EDMS NO.
1973905

REFERENCE
LHC-TCAP-EC-0001

ENGINEERING CHANGE REQUEST

Installation of New Passive Absorbers (TCAPM) for Warm Magnet Protection in IR7

Figure 1 — Illustrative view of the present (top) and post-LS2 (bottom) layouts of the IR7 Q5 [2,3]. The new TCAPM is represented by the brown box immediately upstream of the MQWA.D5. A specular layout is planned for beam 2.

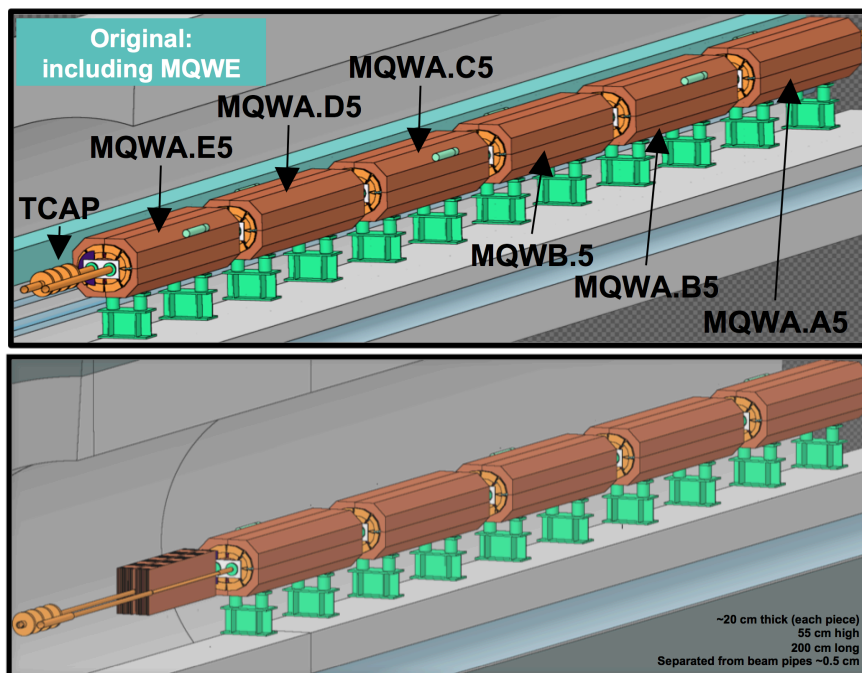
The requirements and a detailed performance assessment of possible new layouts were discussed in various Collimation Upgrade Specification meetings – see presentations by C. Bahamonde in [2,3,4,5,6]. Figure 1 shows in an illustrative sketch, taken from the FLUKA geometry used in simulations, the present layout (top view) and the modified one (bottom view) [2,3].

The present passive collimator TCAP will remain in place and the new passive absorber TCAPM will be added. The latter is outside the vacuum, contrary to the existing passive absorbers. The same elliptical chambers as the present MQW one will be used in this area. The vacuum layout is described in detail in [1] so we focus here only on the new absorber outside vacuum.

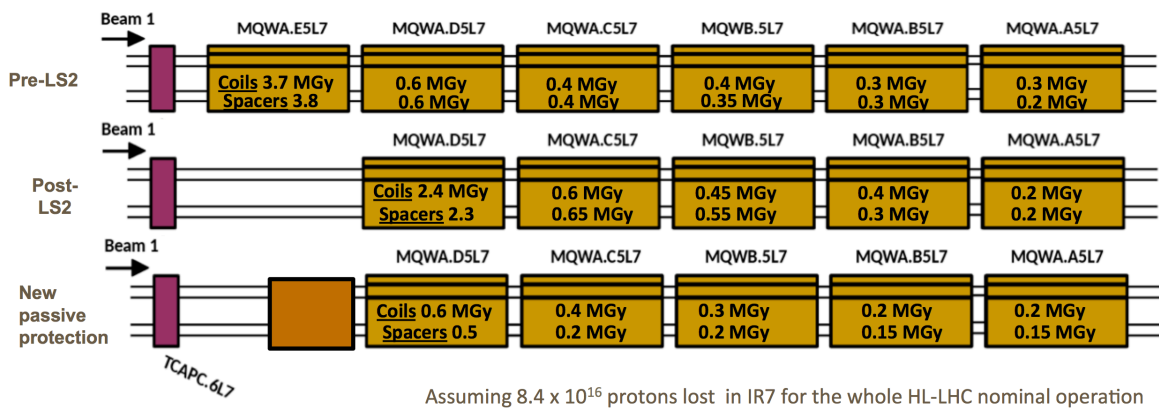
The computed doses in all modules of the Q5 magnets for beam 1, estimated for the whole lifetime of the HL-LHC project [7], are illustrated in Figure 2 for three different layouts [2,3]:

- Present layout (top graph);
- Hypothetical layout without collimation upgrade after magnet removal (middle);
- Proposed post-LS2 layout (bottom) with TCAPM.

Dose values are estimated both for the coil and for the spacers [1]. Note that for all cases, the present TCAPC.6L7.B1 collimator remains at the same location, as this was found to produce good performance. This also avoids intervening on a radioactive collimator. It is clear that without an improvement of the passive collimation layout (middle plot), doses on the downstream MQWs would be much higher than in the present layout. In particular, the dose on the coil spacers [1] of the most exposed magnet would be about a factor 4 larger. The proposed solution with TCAPM (bottom line) described in detail in the next section, solves this issue and brings the levels to an acceptable level.

Figure 3 — Overall design of the TCAPM. Lengths are given in mm. Courtesy of L. Gentini [8].

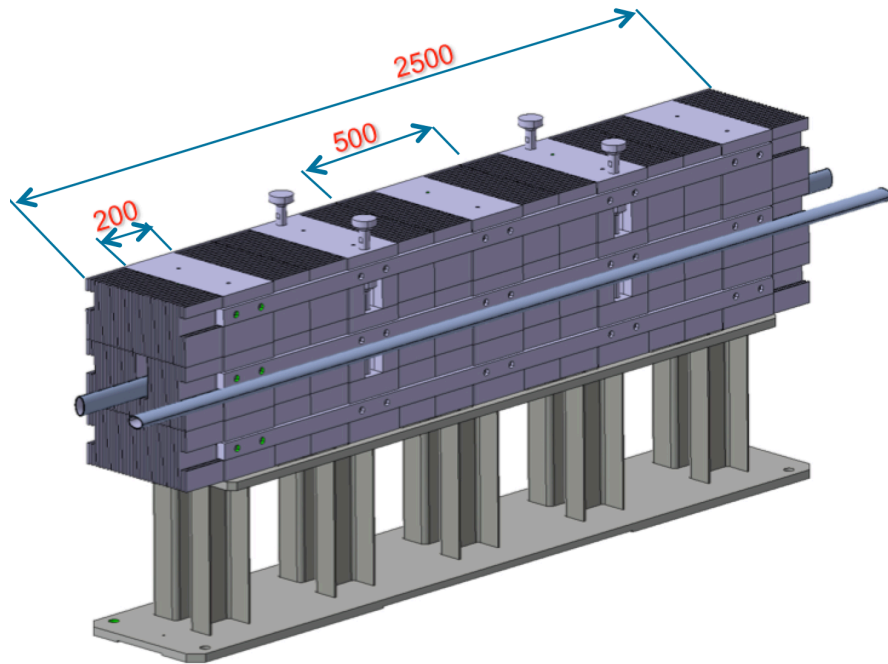
The new absorber's design [8] is shown in Figure 3. A new support that will be installed under the vacuum chamber will house a modular structure made of steel blocks, assembled together to fill a volume that ensures adequate shielding of the downstream magnet. The absorbing part consists of three block assemblies shown in Figure 4. The assemblies 1, 2 and 3 weigh respectively 835 Kg, 795 Kg and 820 Kg, for a total of about 2800 kg with the support. The TCAPM transverse cross section is shown in Figure 5. The absorber assemblies are mounted around the elliptical beam pipes in a way that leaves minimum empty spaces. A preliminary integration layout is shown in Figure 6. The longitudinal central positions of the new passive absorbers are 19852.4964 m for B1 and 20135.8284 for B2.
